Thank you for submitting to SPU the solid waste service plans for the proposed project at **8601 Fremont Ave N.**, subject to review by the Seattle Department of Construction and Inspections (SDCI) as Permit **#3036119-LU**.

SPU has reviewed your solid waste plans and approves the following conditions:

Boys & Girls Club - Commercial

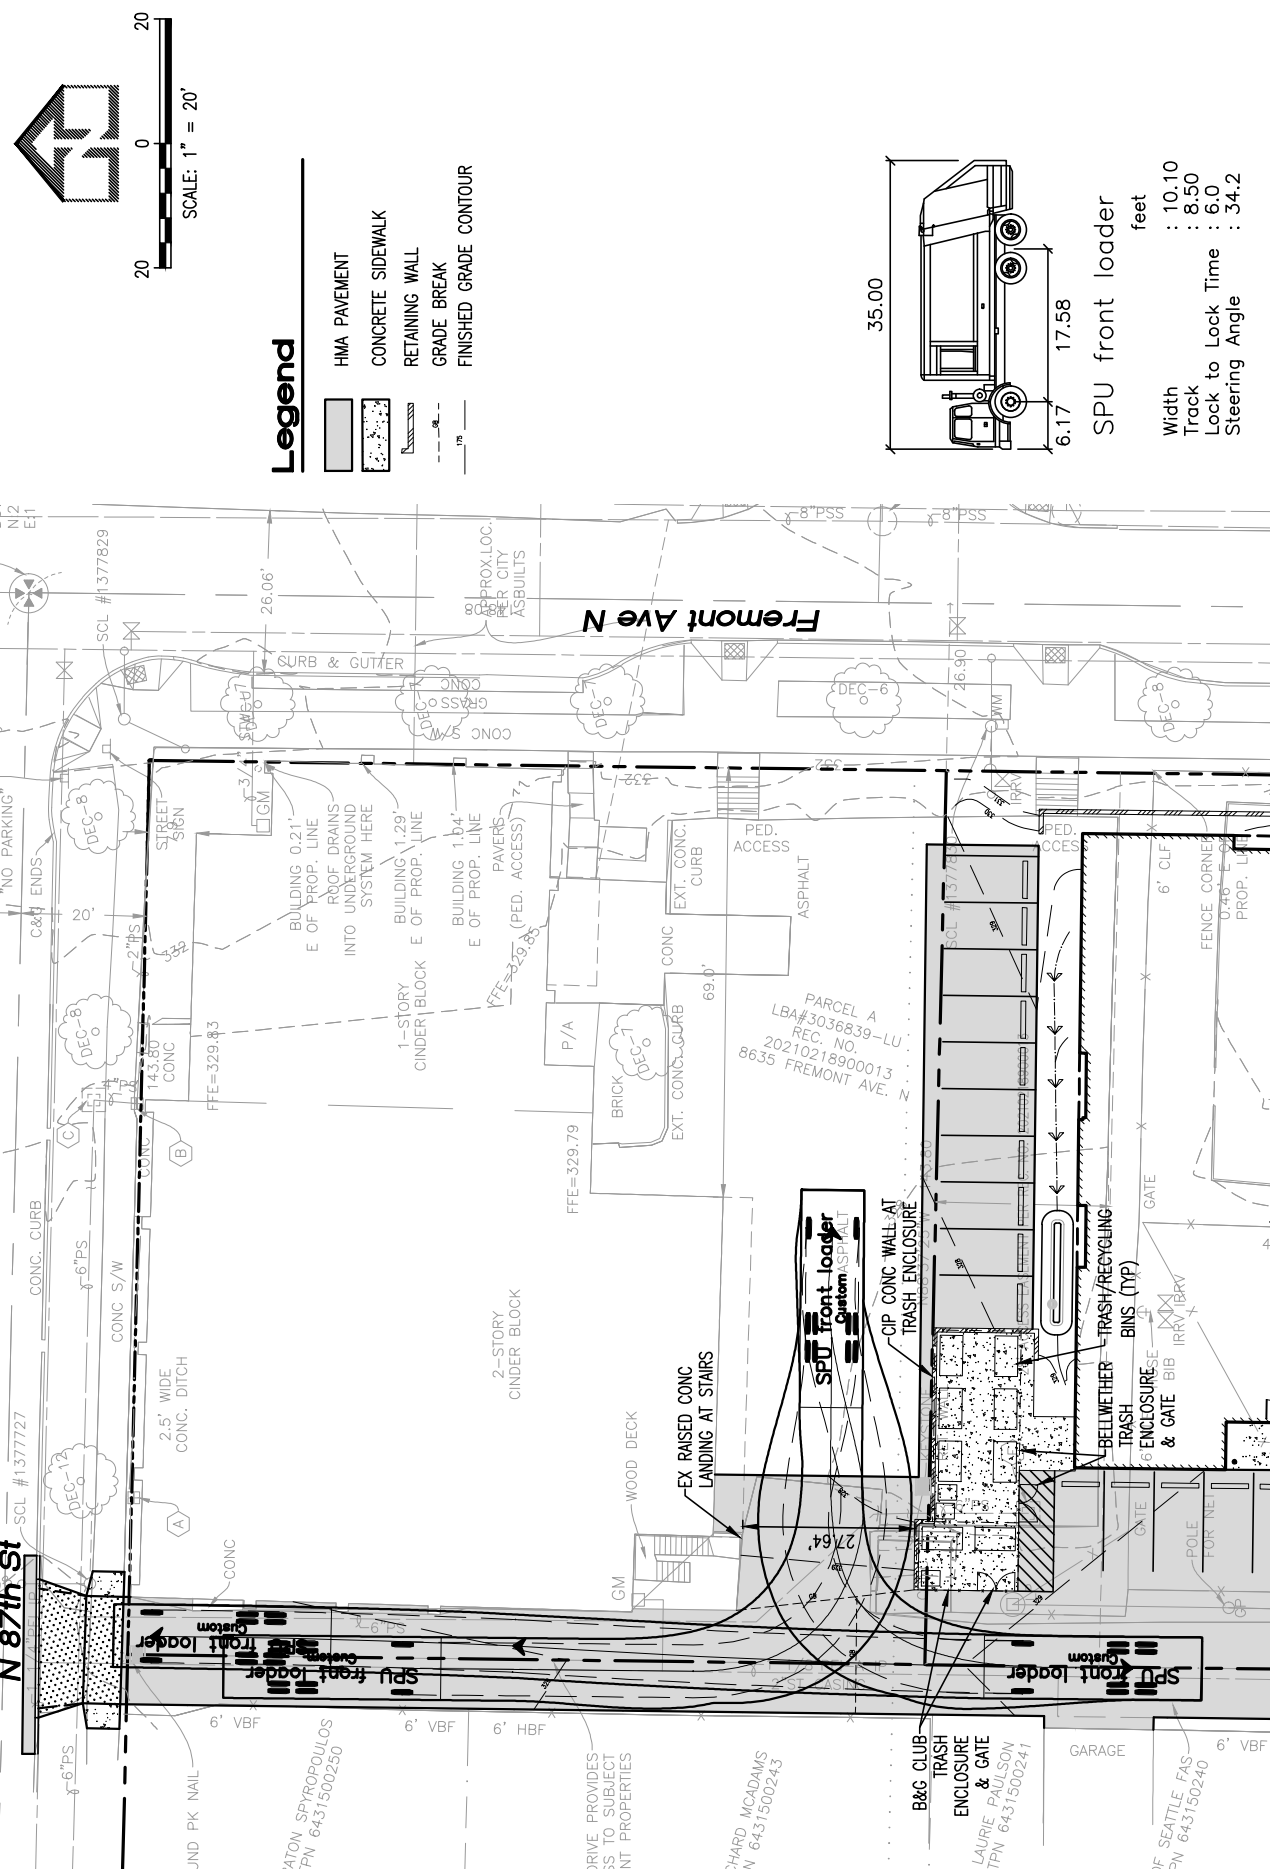
- An easement exists for Bellwether Housing to store solid waste for the **Boys & Girls Club**. SPU grants a **modification to 23.54.040.E.1**.
- Separate solid waste services, billing, and storage enclosures will be provided.
- A turnaround is provided on the Bellwether parking lot to allow solid waste trucks to access the sites from the alley and turnaround.

- Recycle: 1 – 2yd dumpster
- Garbage: 1 – 2yd dumpster
- Compost: 1 - 96-gal cart
